**Supplemental Site Investigation  
Sampling and Analysis Work Plan  
Former Coke Plant  
Tecumseh Redevelopment, Inc.**

RCRA Docket No R3013-5-03-002  
Site EPA ID No. IND 005 462 601

Re: In the Matter of ISG Indiana Harbor Inc. and Tecumseh Redevelopment Inc.  
Supplemental Sampling & Analysis Work Plan  
Former Coke Plant

### **TECHNICAL REVIEW Supplemental Site Investigation Sampling and Analysis Work Plan Former Coke Plant**

Figure 4-1  
Investigation Decision Flow Chart  
Tecumseh Redevelopment, Inc. - Former Coke Plant

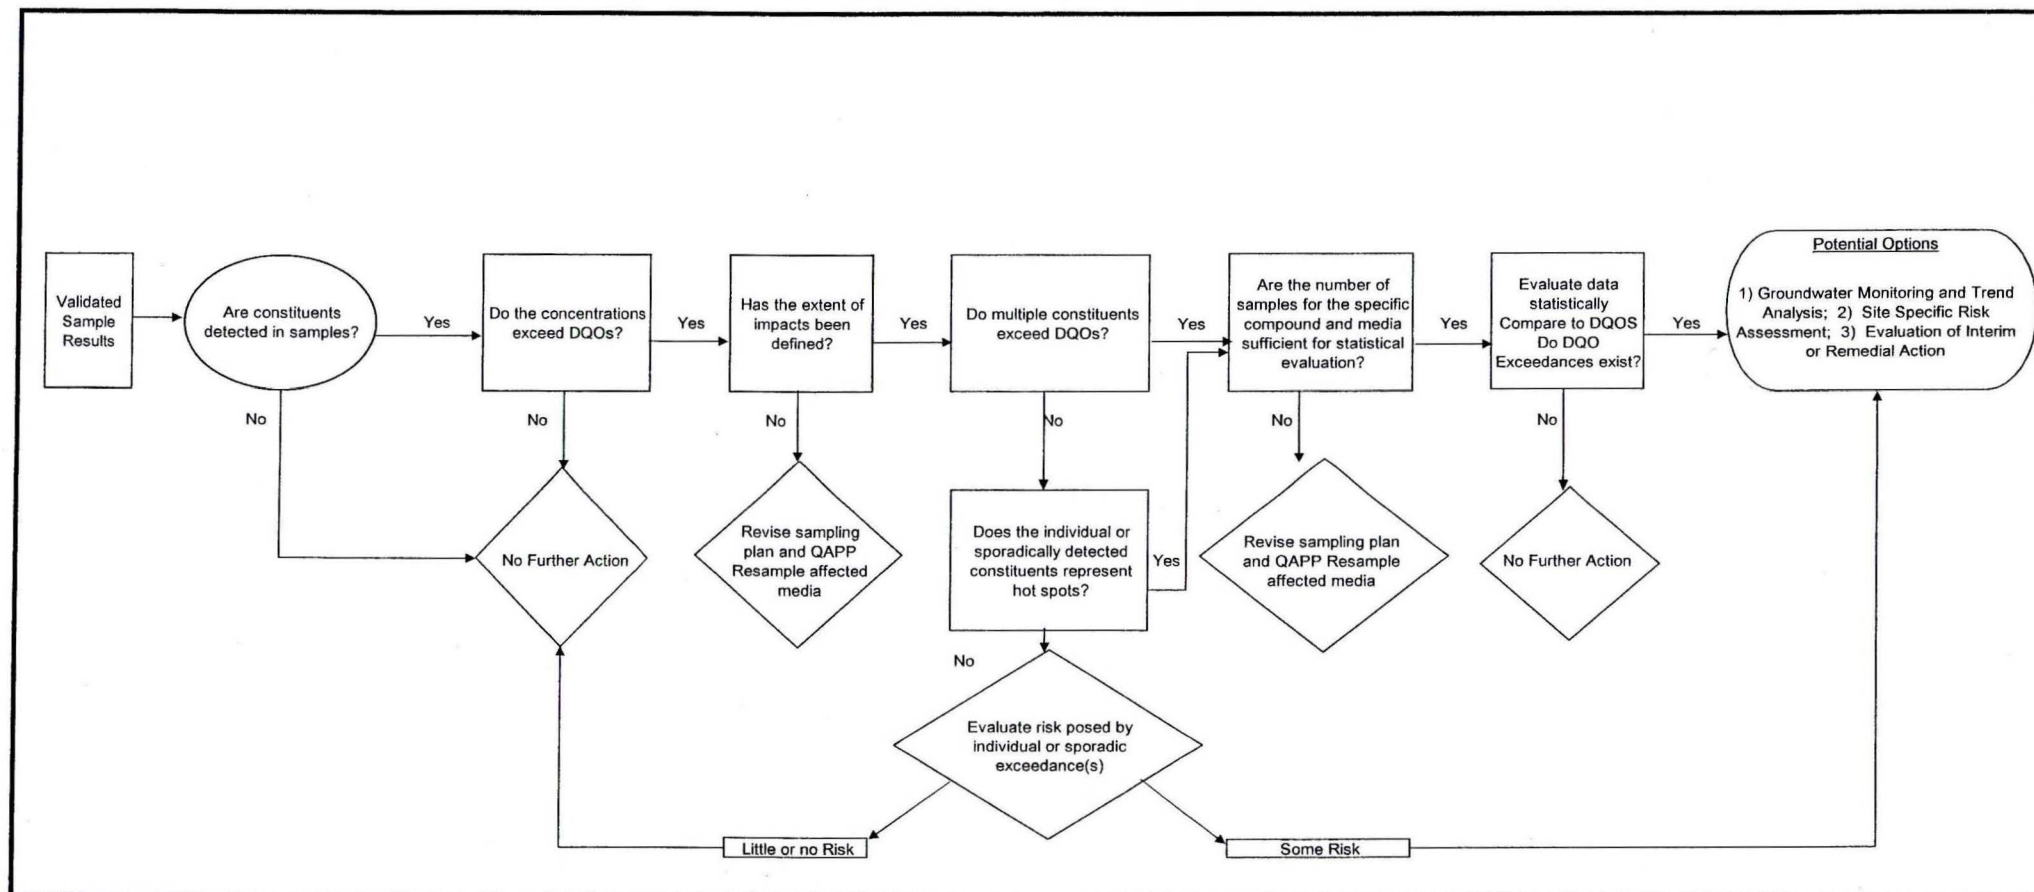
Text states "If there is a single DQO exceedance or sporadic exceedances across the site..." This statement is very unclear. Apparently, this Supplemental Work Plan was designed to provide additional data points. Therefore, any data collected during these investigations should supplement existing data. Therefore, there should be enough information collected for use in the statistical analysis. If not, additional data should be collected for any statistical analysis that is deemed necessary to complete the evaluation.

FIGURE  
NUMBER 5-1

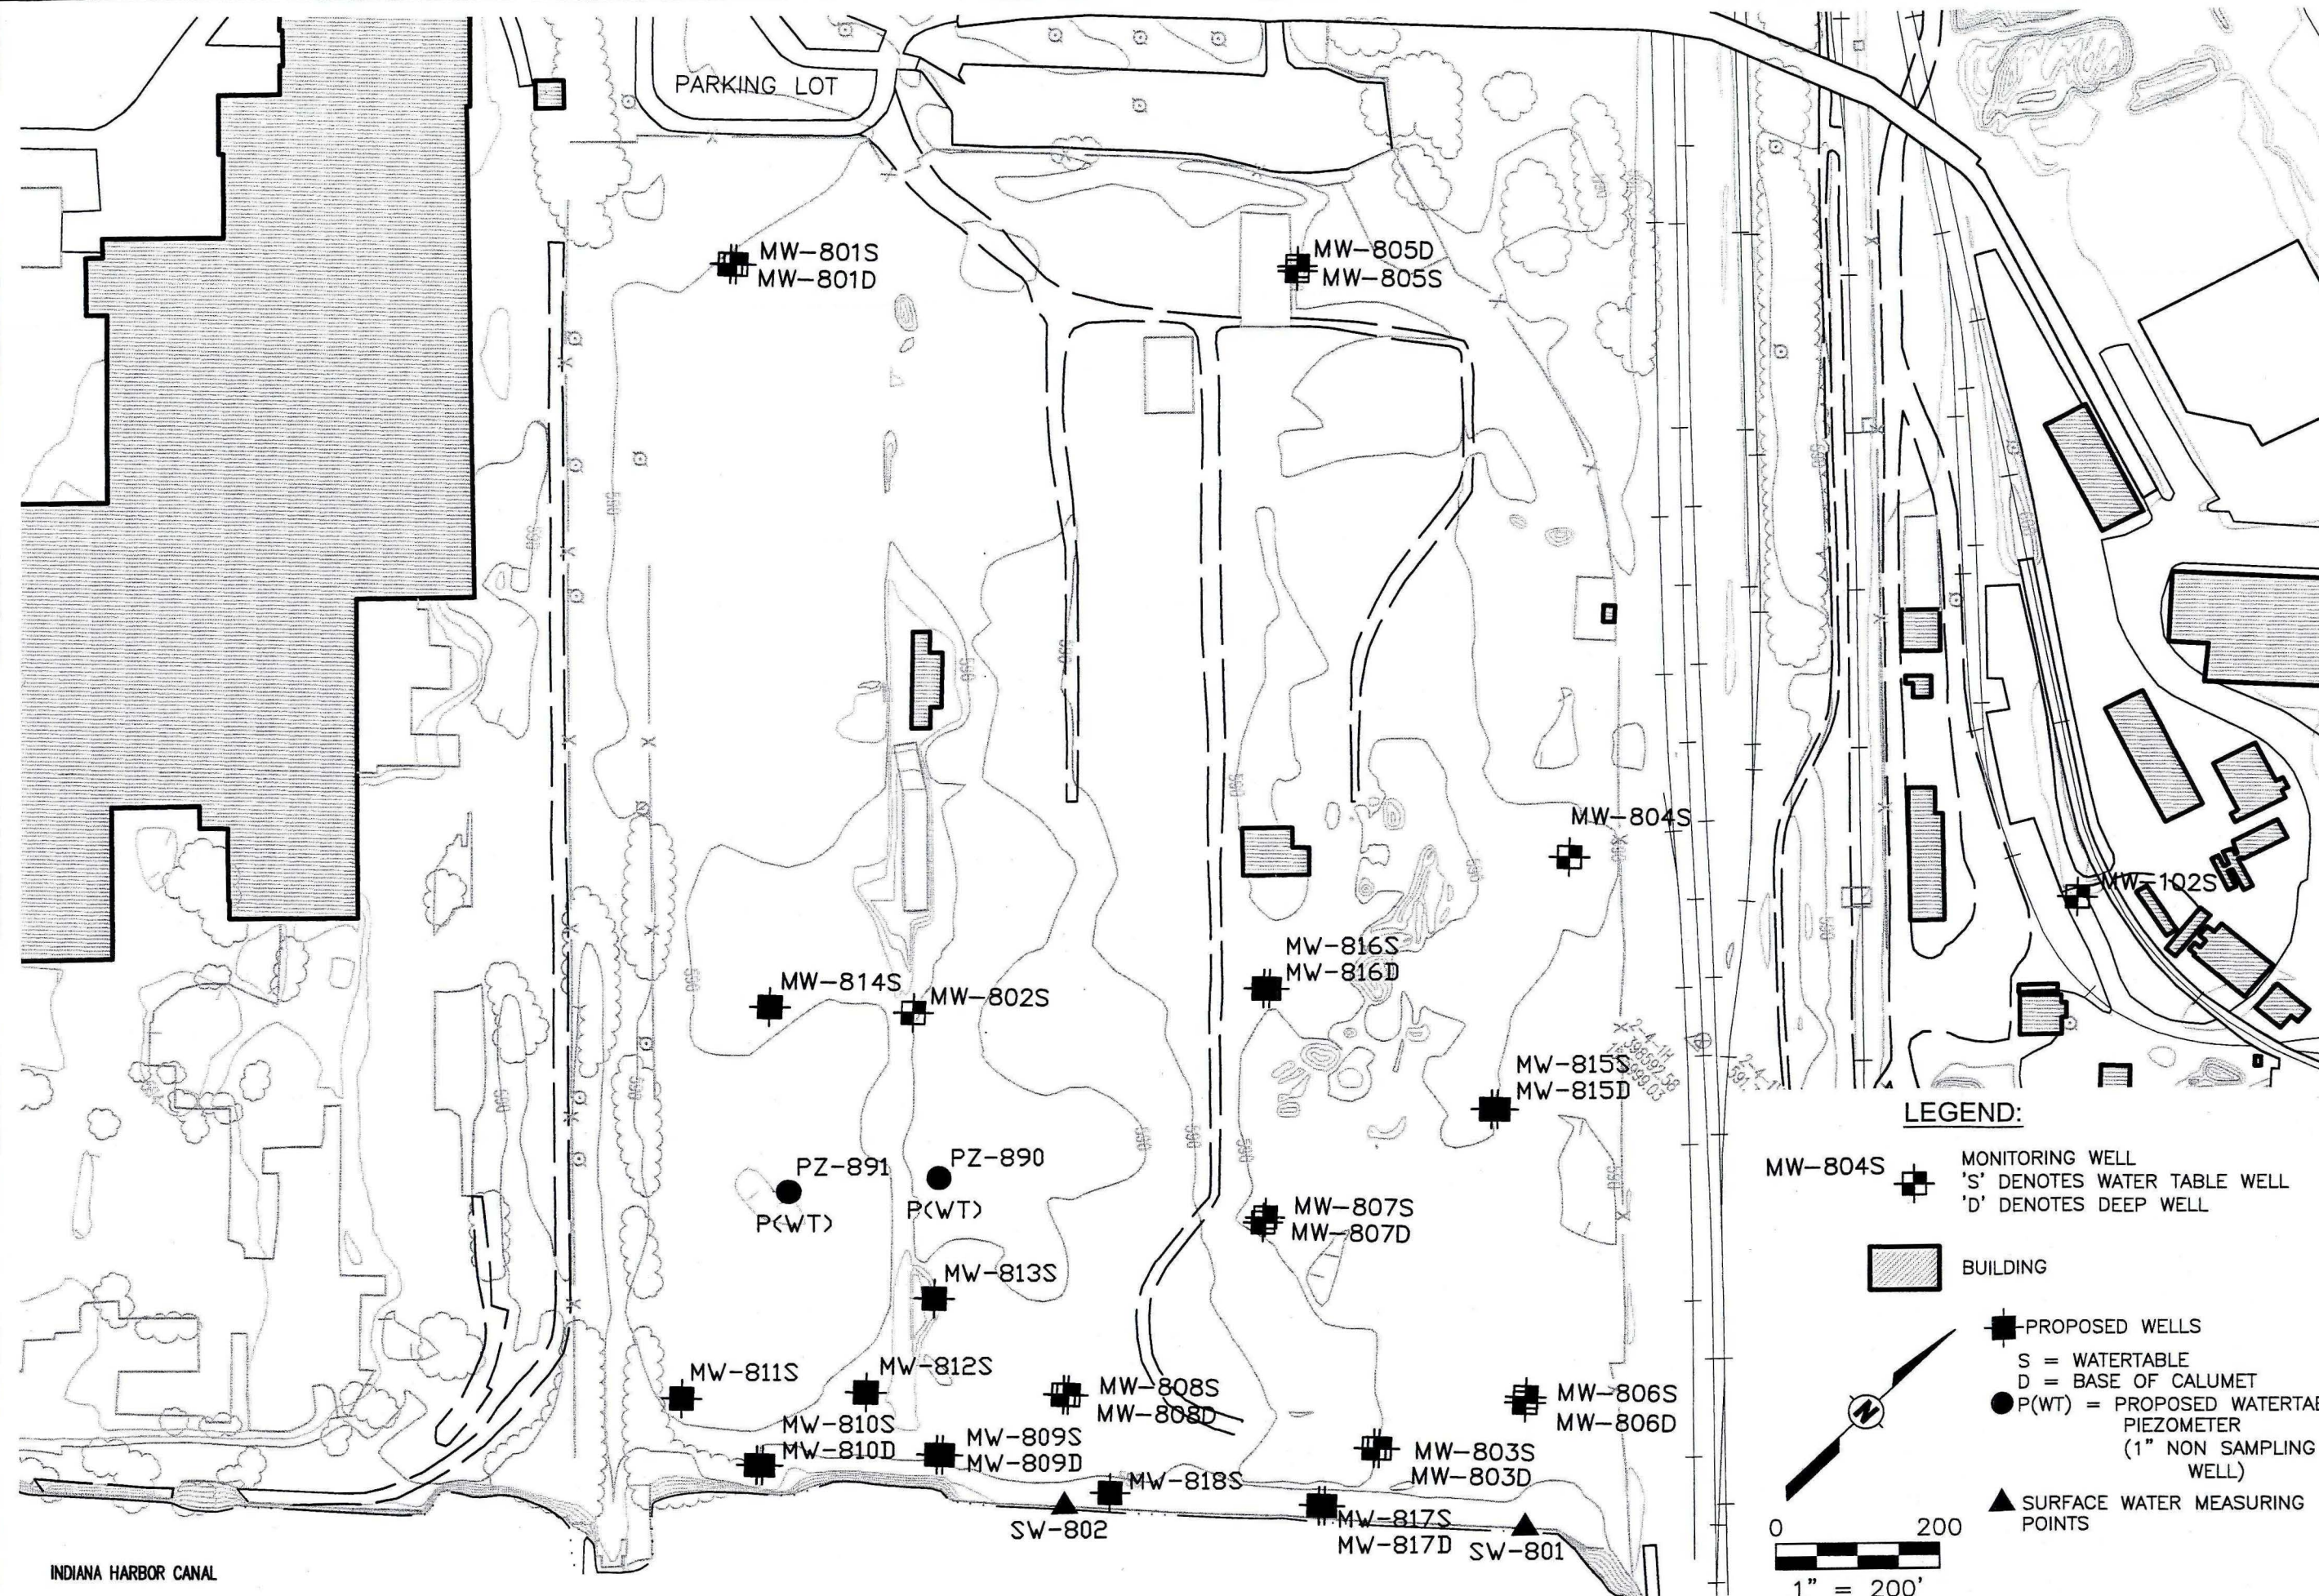
The text described areas to be most likely impacted from the coking operations. However, it is not clear from the text that the Supplemental Work Plan was designed specifically for collecting samples from these likely impacted areas. If so, explain why the proposed sample locations do not reflect these likely impacted areas as you indicate on the map.
